Proposal Outline planning application for the construction of up to 140,000 sqm of employment floorspace (use class B8) with ancillary offices and facilities and servicing and infrastructure including new site accesses. Internal roads and footpaths, landscaping including earthworks to create development platforms and bunds, drainage features and other associated works including demolition of the existing farmhouse.

Location Land east of Junction J.11, M40, Banbury

Application No. 23/03428/OUT

Following submission of the Flood Risk Assessment and Drainage Strategy (FRA & DS) produced by Delta-Simons (dated May 2022 Project No: 21-2141.01), the LLFA response was included with Oxfordshire County Council composite response dated 12th of February 2024, the LLFA objected to the development. The detailed comments from the LLFA are reproduced and Mabbett's responses on behalf of the applicant are below.

Drawing
**Conceptual Drainage Sketch
Catchment A**

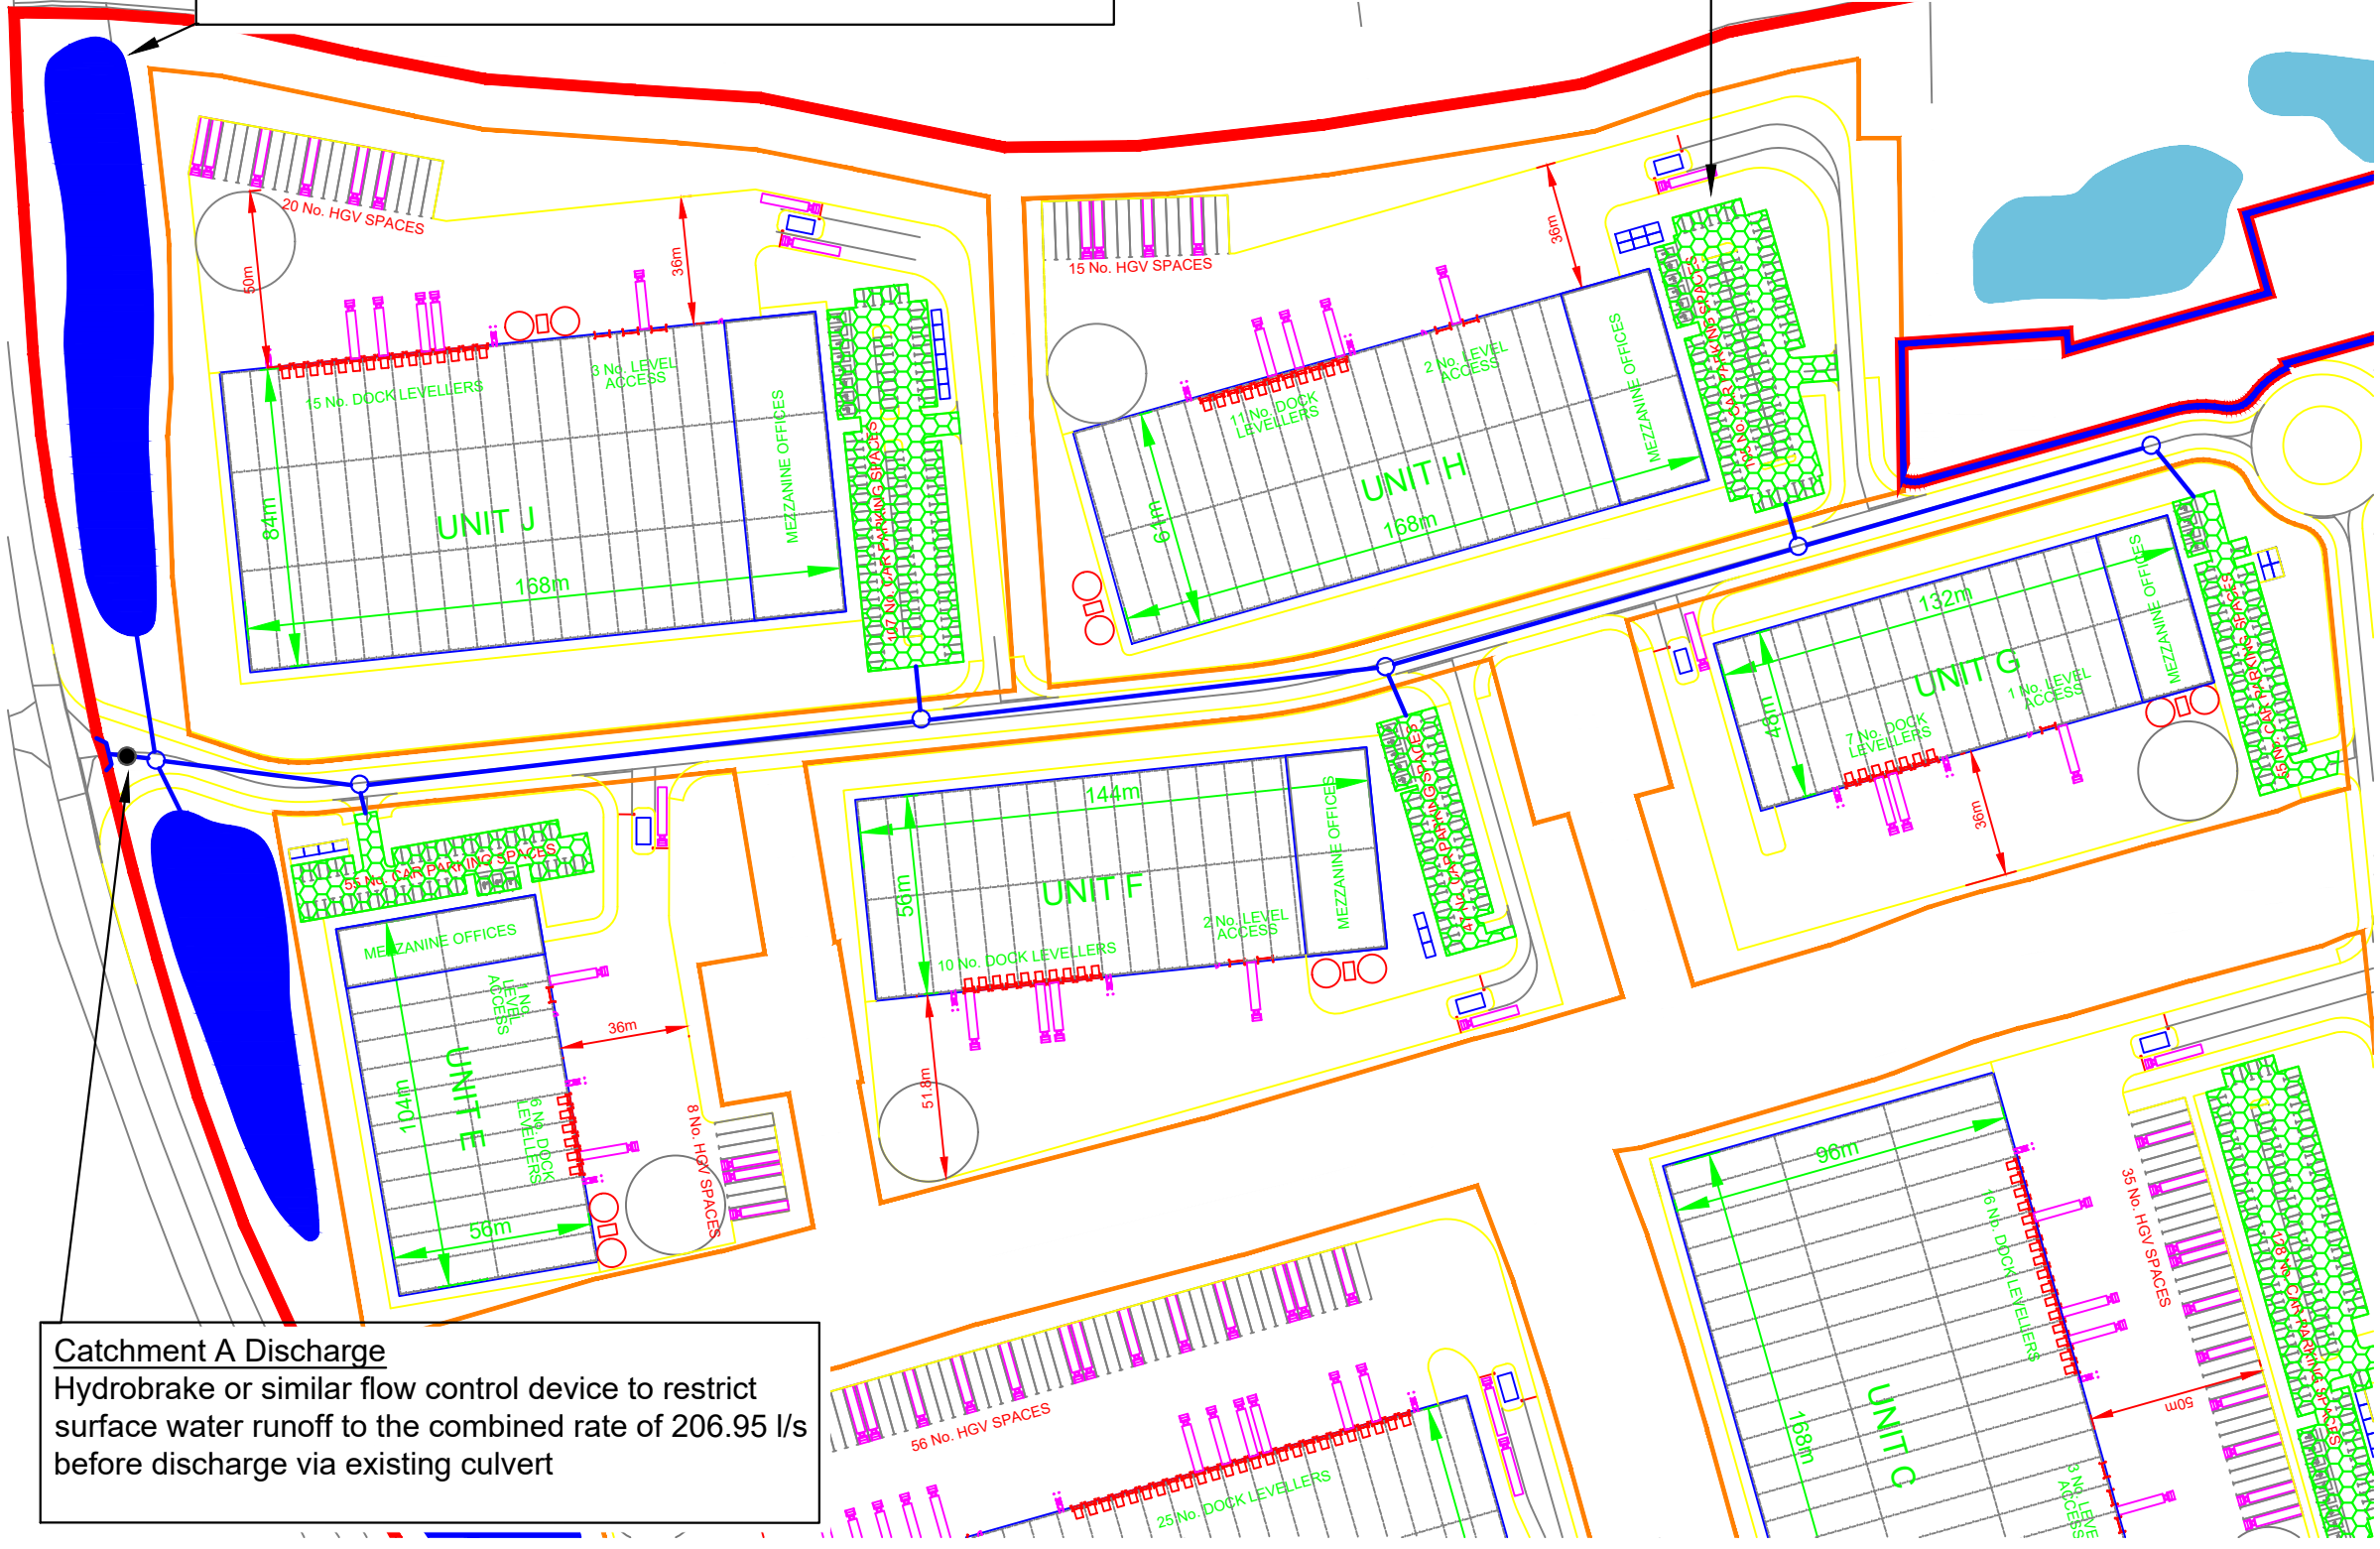
"The FRA explains the surface water drainage strategy however a surface water drainage drawing is required to demonstrate the surface water strategy. Proposed SuDS features and drainage infrastructure needs to be shown indicatively. Outfall locations to be shown, storage details of proposed SuDS features and infiltration rates if applicable".

A Surface Water Drainage Drawing is included in Appendix A of this letter.

As described in the Delta-Simons FRA & DS, surface water runoff will be discharged to the neighbouring site's drainage system and ultimately the River Cherwell via two culverts along the western Site boundary at a combined maximum rate of 460.51 l/s.

Surface water runoff up to the 1 in 100 year plus 40% climate change allowance event will be attenuated on site. A total attenuation volume of 21,526 m³ will be required to achieve the discharge rate and will be provided in the form of ponds, swales or detention basins located in the west of the Site and also within permeable paving.

The Drainage Drawings shows that the require amount of attenuation is available within the car parking areas and the proposed ponds within the north-western extent and within the demise of the southern plots.

Catchment A Attenuation Ponds
Attenuation Ponds with a combined surface area of 6,569.79m².
Ponds will be 1.5m deep with banks at a gradient of 1 in 3.
Ponds will provide 9,854.68m³ of attenuation

Catchment A Permeable Surfacing
Permeable Surfacing with a surface area of 9,184.7m², with a sub-grade depth of 0.4m and a void ratio of 30%, totaling in 1,102.16m³ of attenuation

Catchment A Discharge
Hydrobrake or similar flow control device to restrict surface water runoff to the combined rate of 206.95 l/s before discharge via existing culvert

Drawing
**Conceptual Drainage Sketch
Catchment A Area**

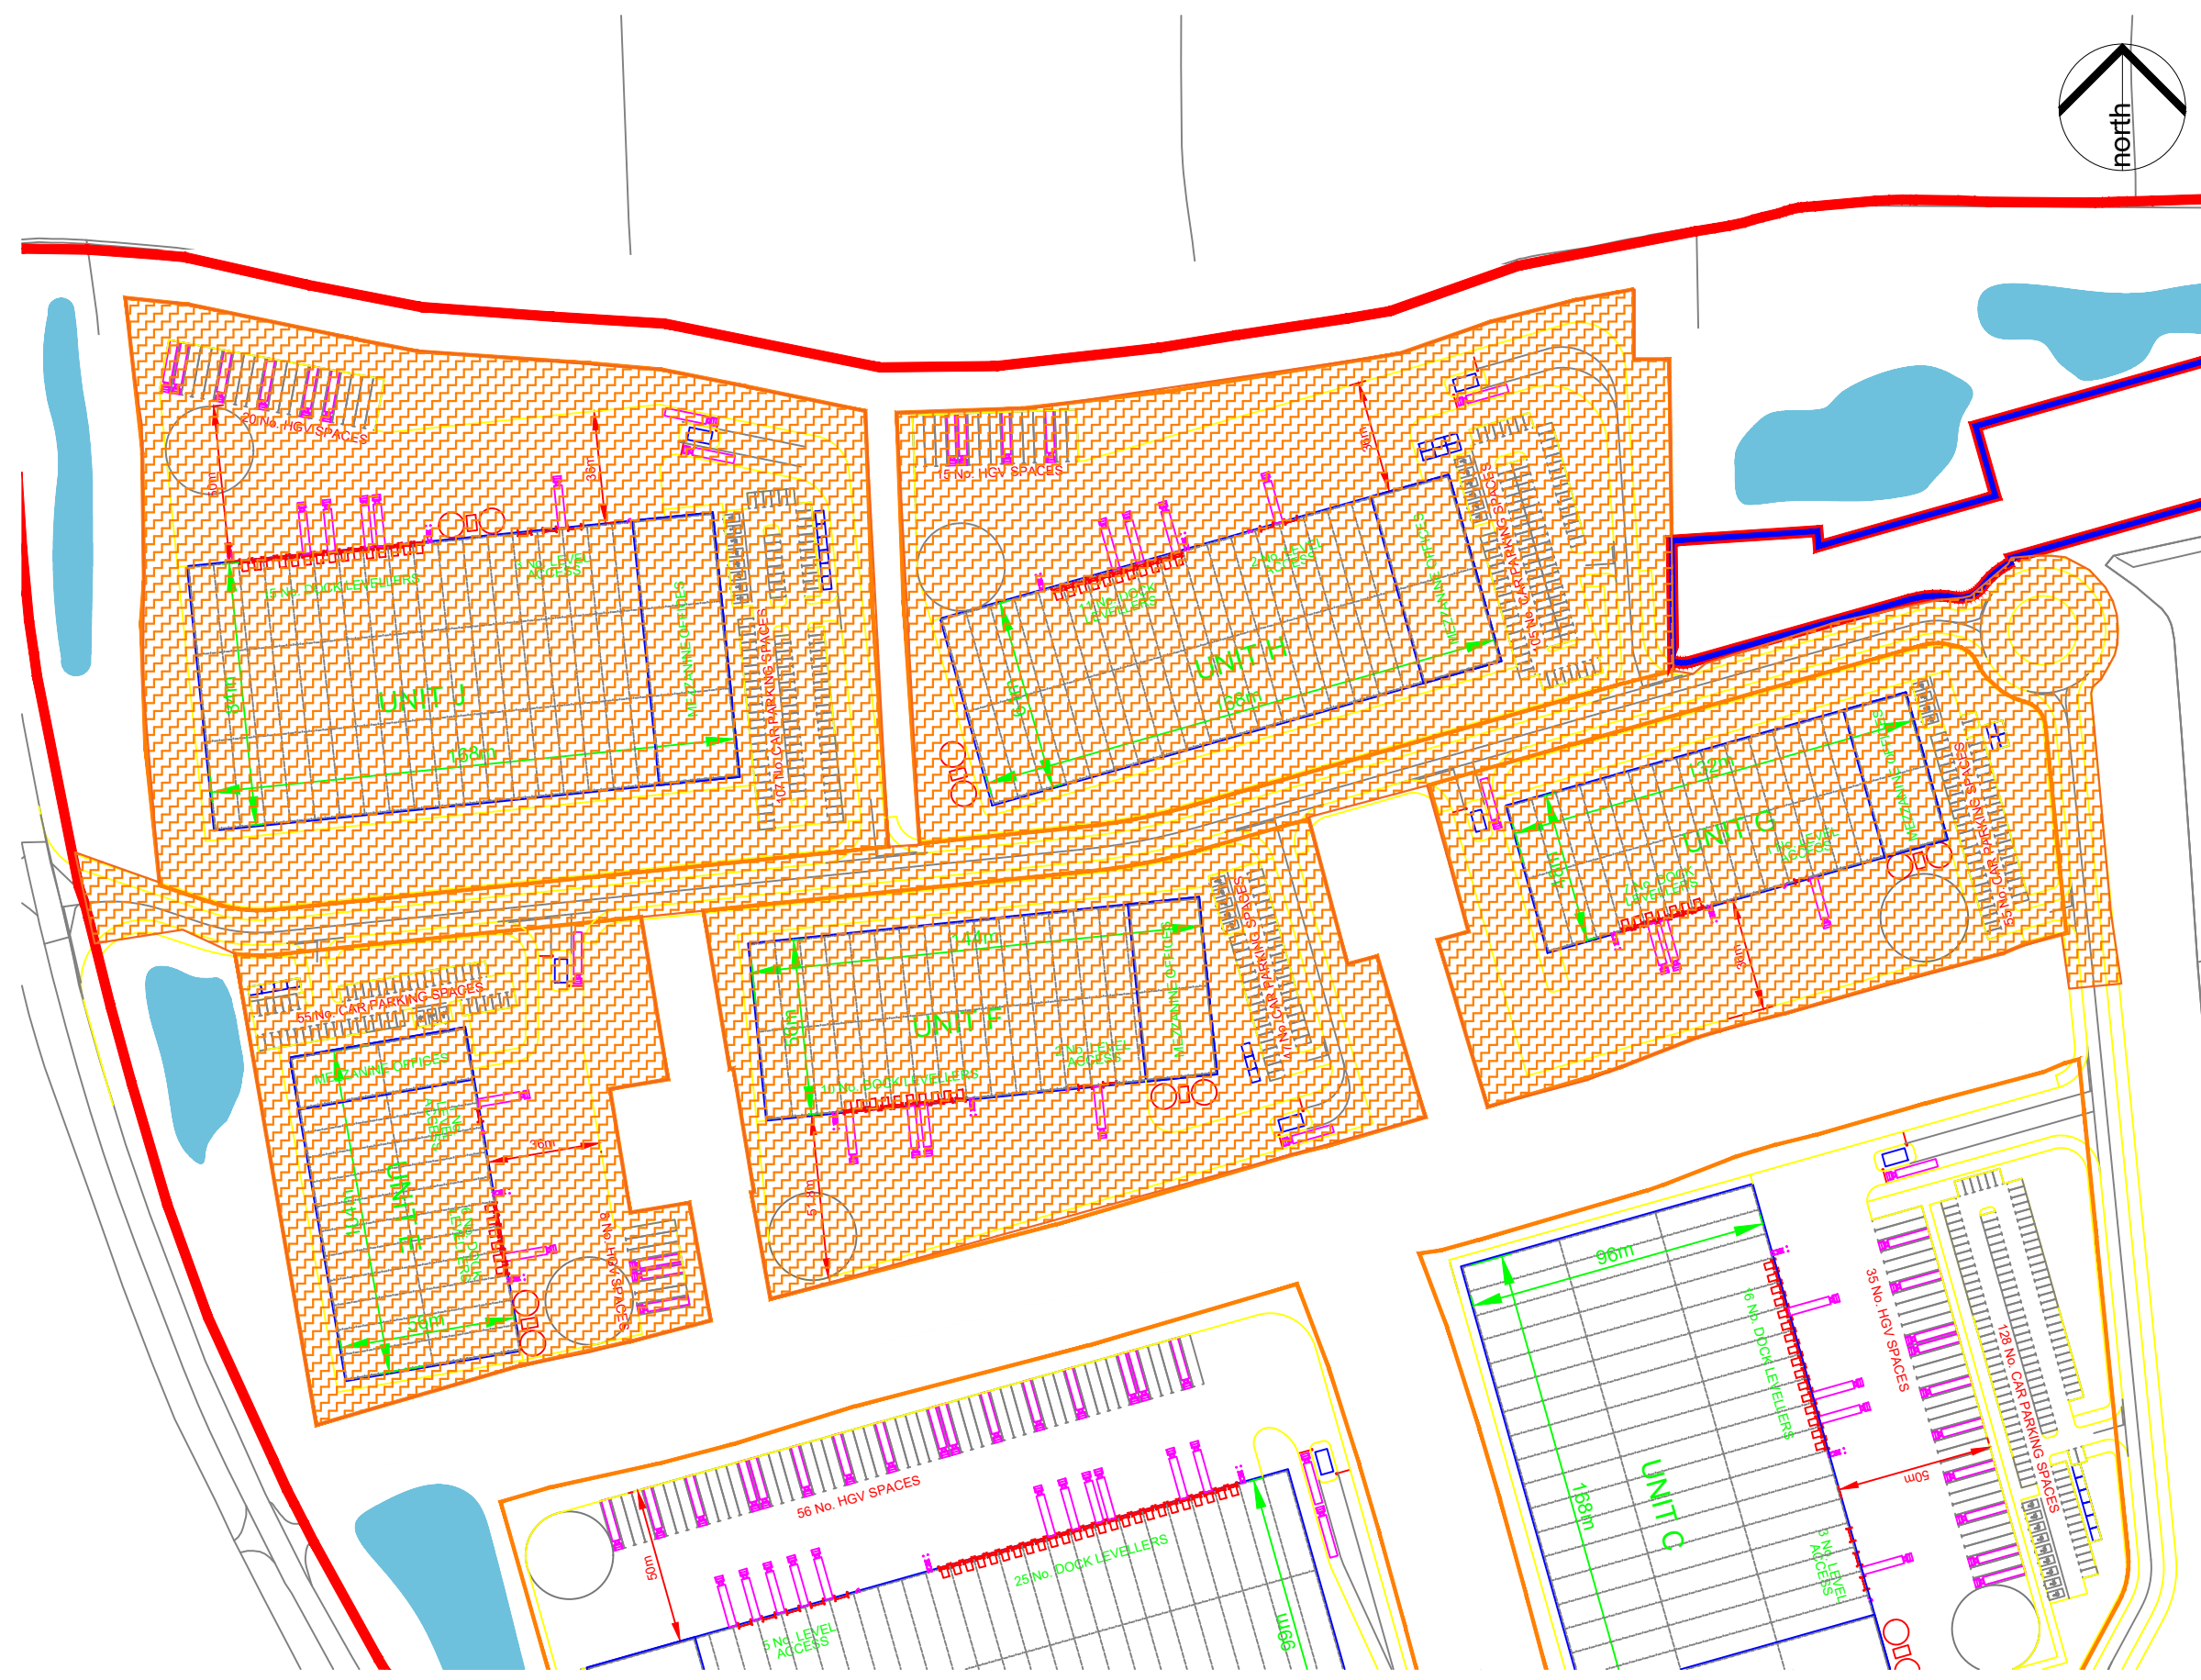
“The catchment areas have been broken down in the FRA, however a Catchment plan is required to highlight the extent of the areas. Stating the total impermeable area and the impermeable area including urban creep”.

A Catchment Plan is included in Appendix B of this letter.

The site can be split into two catchments each served by the two existing culverts at the lowest extents of the site. The site can be further split into individual plot catchments at the detailed design stage if required. It is reiterated that the layout is not fixed, and the catchment areas may change as a result of works undertaken at the detailed stage.

Area (m ²)	Discharge Rate (l/s)
Catchment A	143,060	206.9
Catchment B	175,287	253.56
